Technical Bulletin

Bulletin No: TCH-006-005

Subject: BENDIX® DS-1™ AND DS-2™ DOUBLE CHECK VALVE AND STOPLIGHT SWITCHES BECOME OBSOLETE

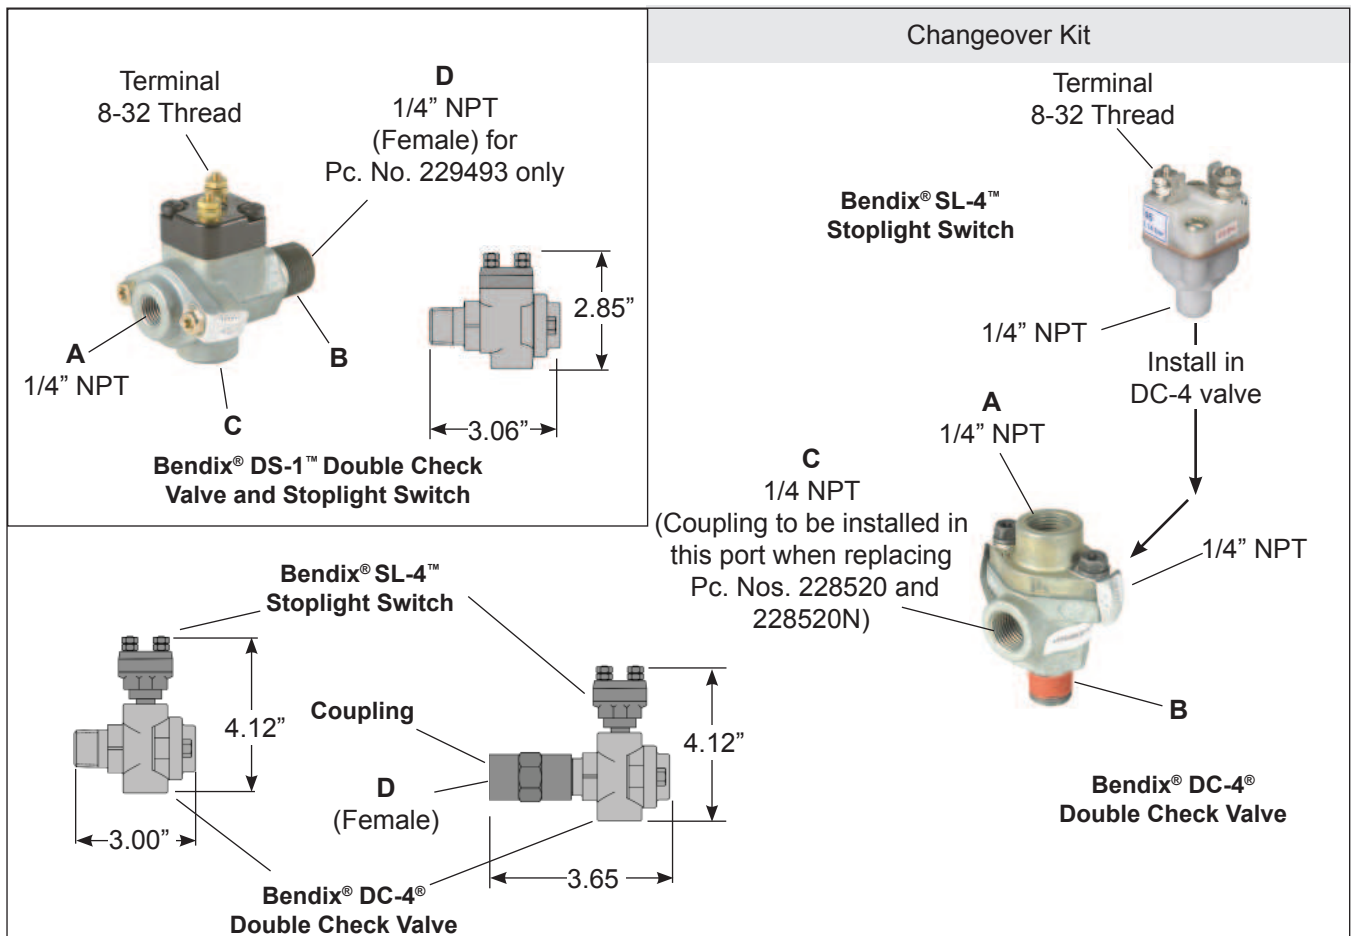
Effective immediately, the Bendix® DS-1™ and DS-2™ double check valve and stoplight switches are obsolete and can no longer be ordered from Bendix. To service these valves, two separate valves — a double check valve and a separate stoplight switch — can be installed together to achieve the same functionality. To facilitate the changeover, Bendix is providing changeover kits which include the valves and necessary couplings. The changeover tables below — and on the following page — identifies the changeover kit piece numbers.

Note that the functionality of the two valves mounted together is the same, however the overall size of the two components mounted together is not. Be sure to review the dimensions of the assembly and verify the installation before attempting the valve replacement.
